2025 GROUP B PROPOSED CHANGES TO THE I-CODES

April 27 – May 6, 2025
Doubletree by Hilton
Universal Orlando - Orlando, FL

Publication Date: March 2025

FIGURE 2308.6.1 JOIST BORING AND NOTCHING LIMITS

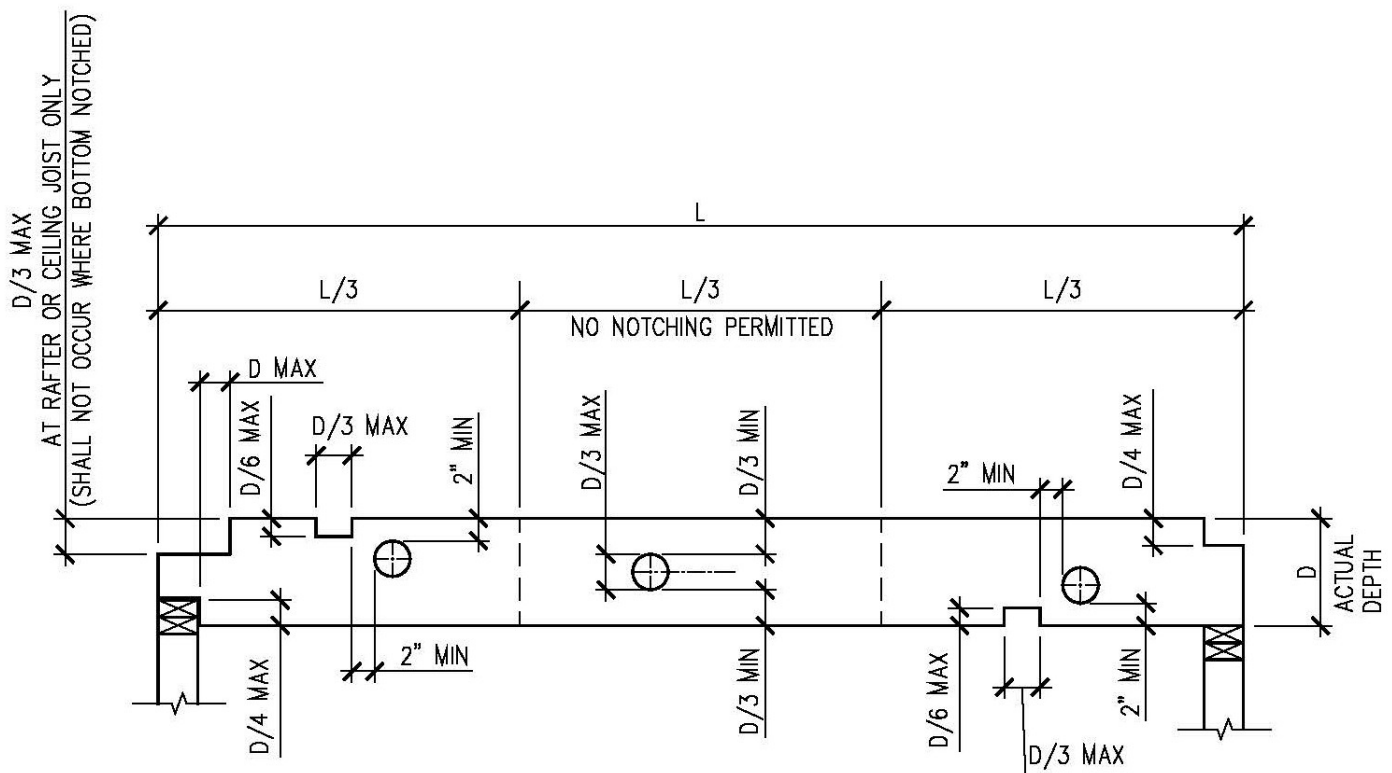
Add new text as follows:

FIGURE 2308.6.2 WALL BORING AND NOTCHING LIMITS

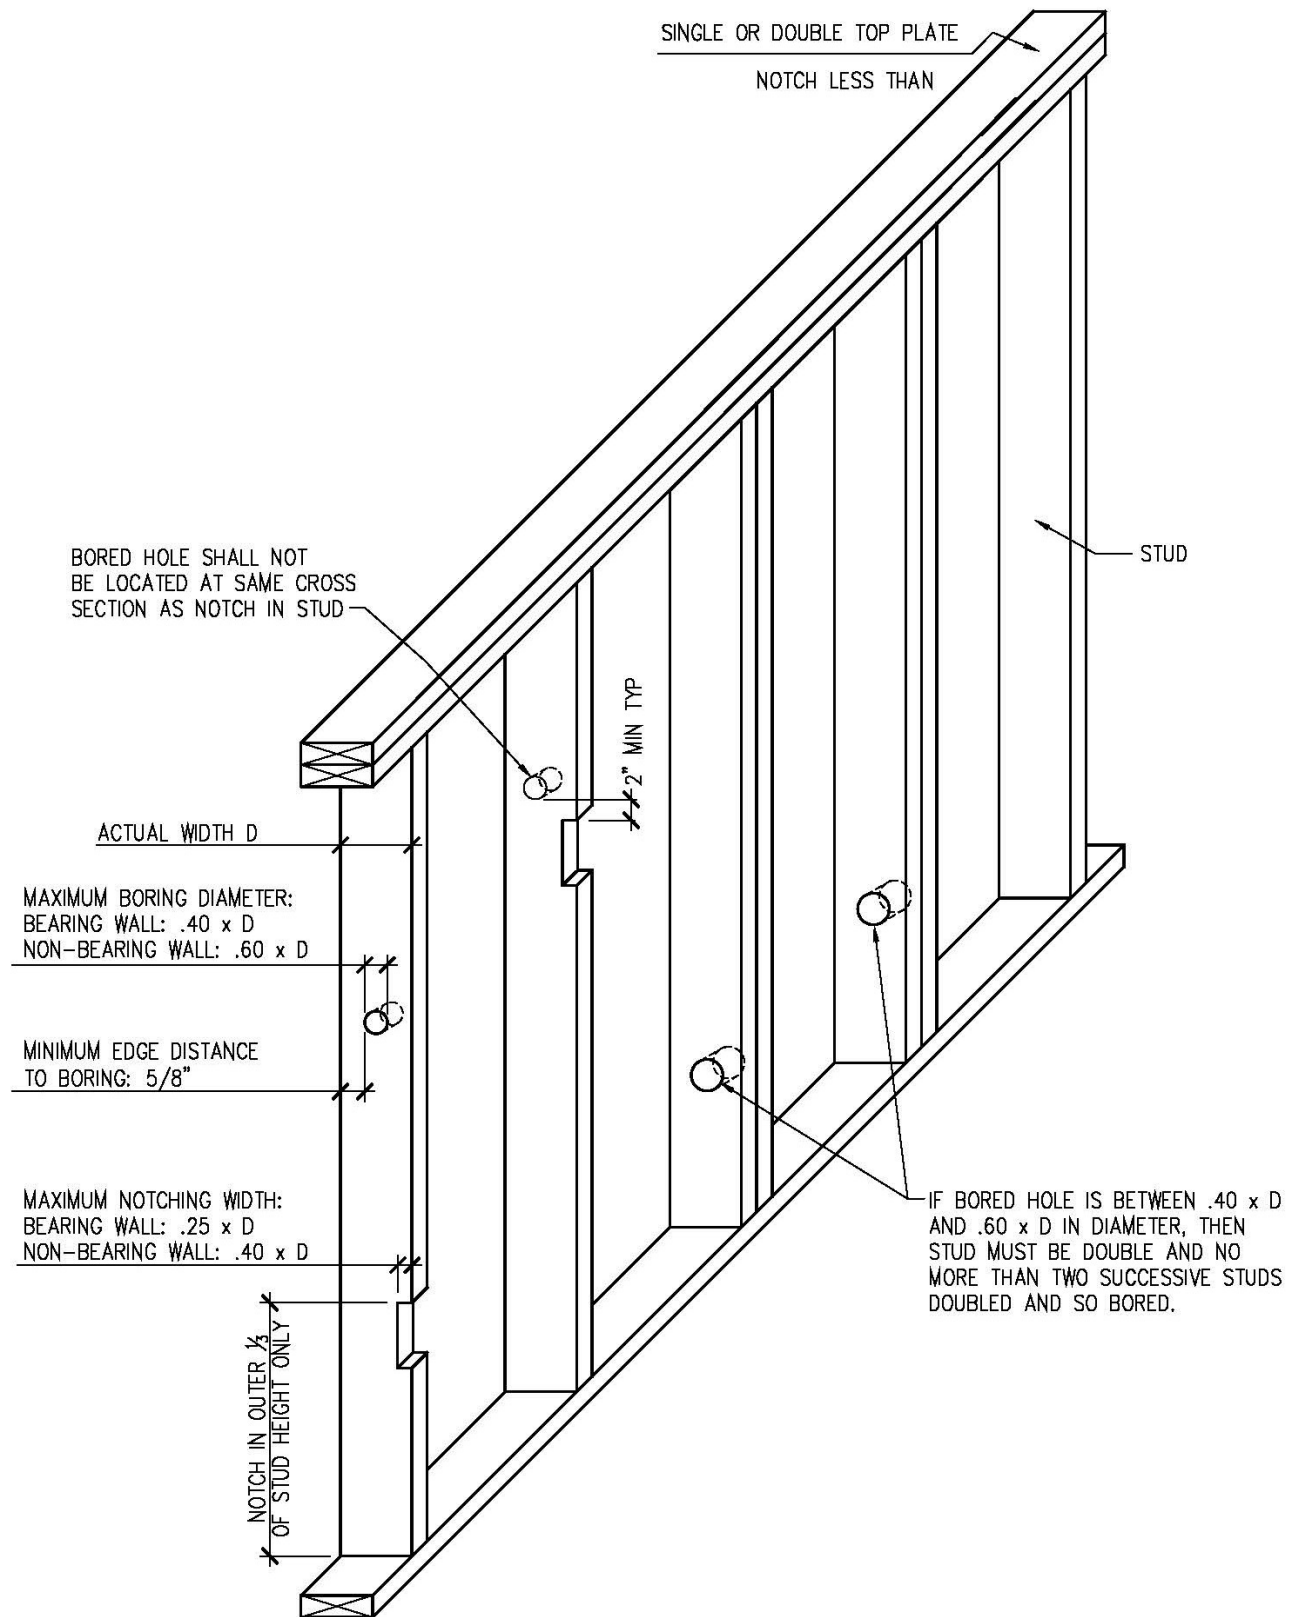
Add new text as follows:

[BS] FIGURE A304.3.1(2) ALTERNATIVE SILL PLATE ANCHORING IN EXISTING FOUNDATION—WITHOUT CRIPPLE WALLS AND FLOOR FRAMING NOT PARALLEL TO FOUNDATIONS^{a, b}

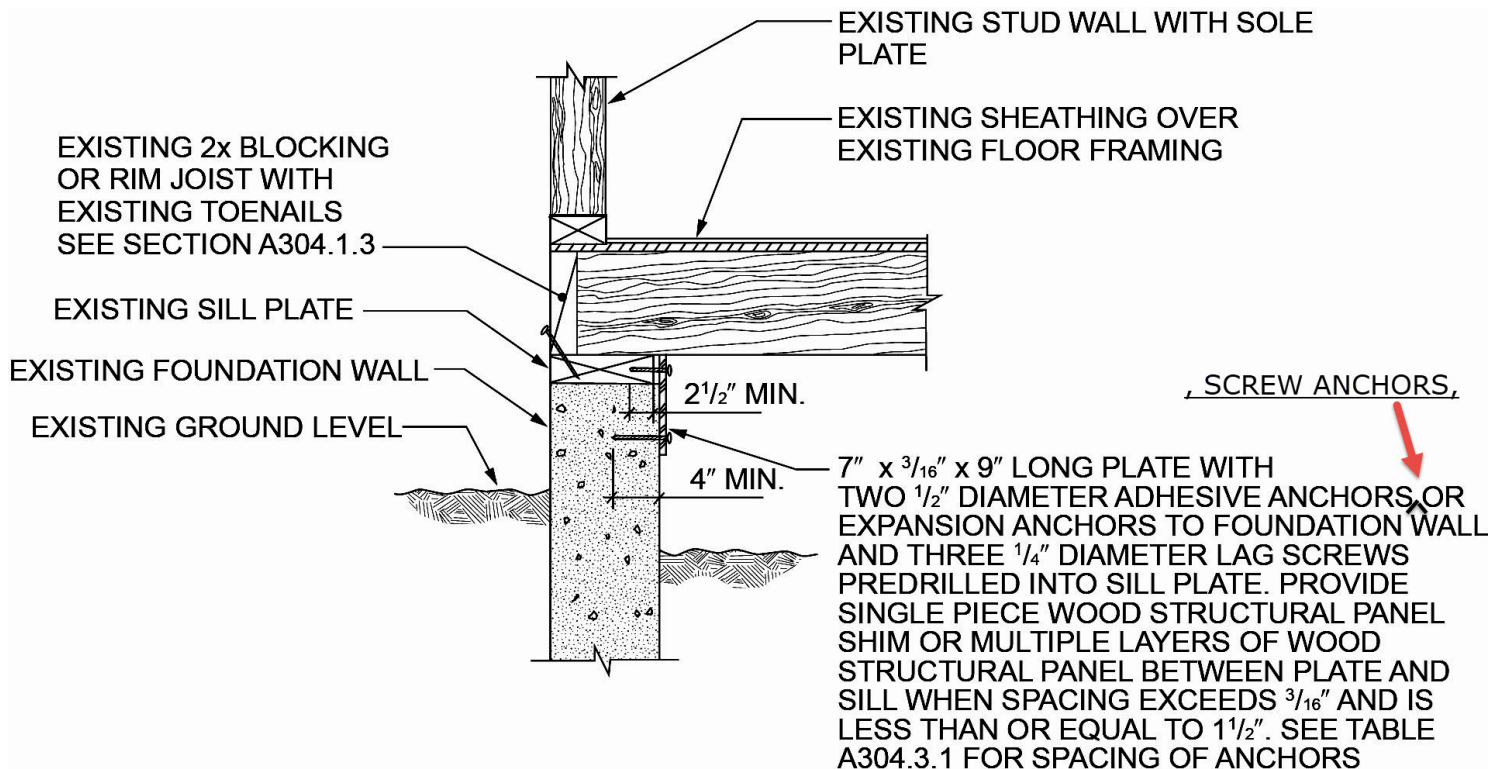
- a. If shim space exceeds 1 1/2 inches, alternative details will be required.
- b. Where required, single piece shim shall be naturally durable wood or preservative treated wood. If preservative treated wood is used, it shall be isolated from the foundation system with a moisture barrier.

Figure R301.2.1.6 Wind-driven rain wind speed (mph, 3 sec gust)
[For SI: 1 mph = 0.447 m/s]

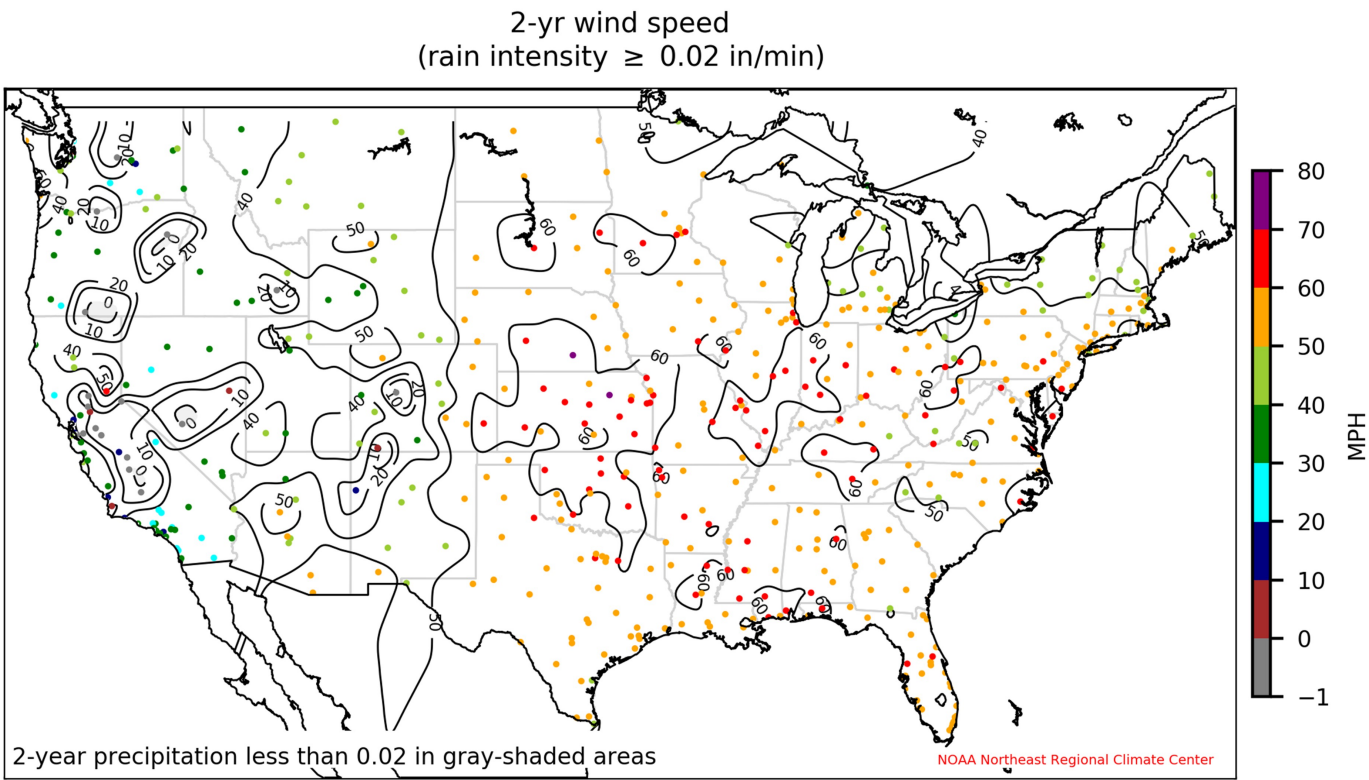
R301.2.1.6 Wind-driven rain. Minimum design wind pressures used to evaluate the wind-driven rain resistance of building assemblies and components shall be permitted to be determined in accordance with Figure R301.2.1.6 and Table R301.2.1.6.

FIGURE R302.1.1 - DIAGRAMMATIC ZERO LOT LINE SEPARATION

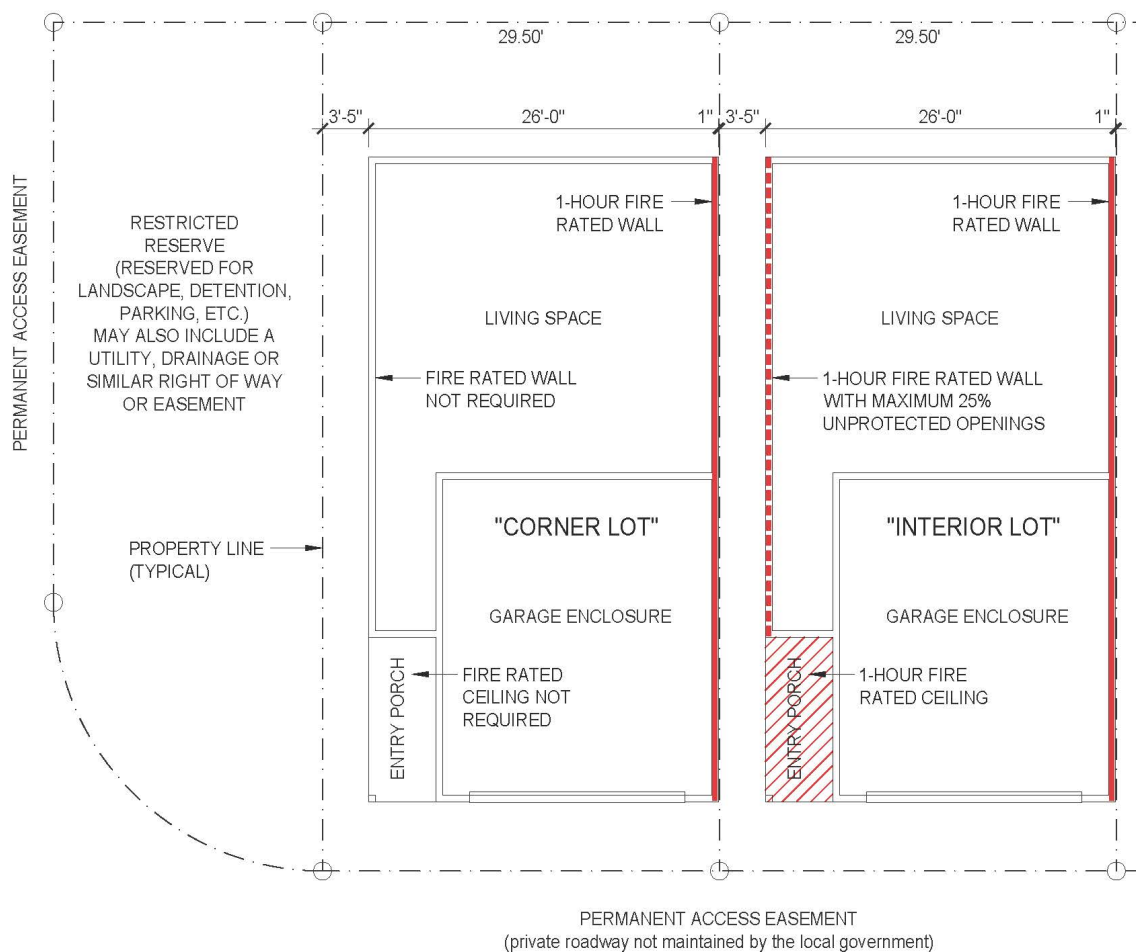
R302.1.1 Zero lot line separation. Where perpetual, platting, and recorded easements create a non-buildable minimum fire separation distance of at least 6 feet between structures on adjacent properties, the one-hour fire-resistive ratings shall not apply as illustrated in Figure R302.1.1.

FIGURE R330.8.1 ESS VEHICLE IMPACT PROTECTION

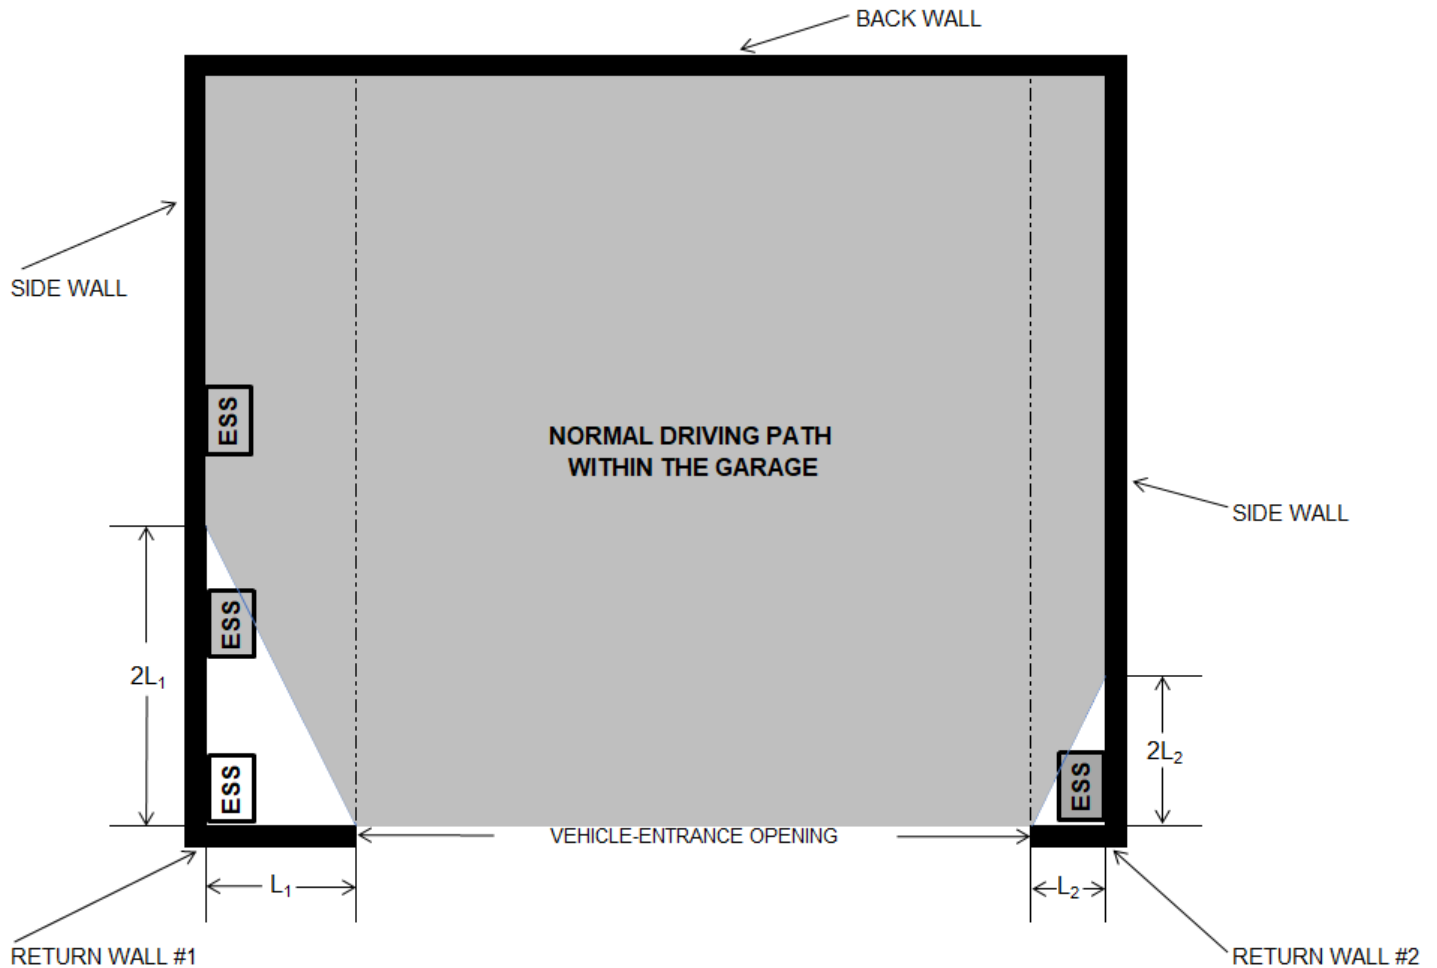
R330.8.1.1 Return-wall protection. Where no portion of an ESS unit is installed outside of a triangle created by connecting a point measured along the side wall that is two times the return-wall measurement (2L) to a second point where the return wall terminates at the vehicle-entrance opening, in accordance with Figure R330.8.1.1, the return wall shall be considered to serve as the required impact protection for that ESS unit. where: L = The length of the vehicle-entrance return wall, measured from the inside corner where the return
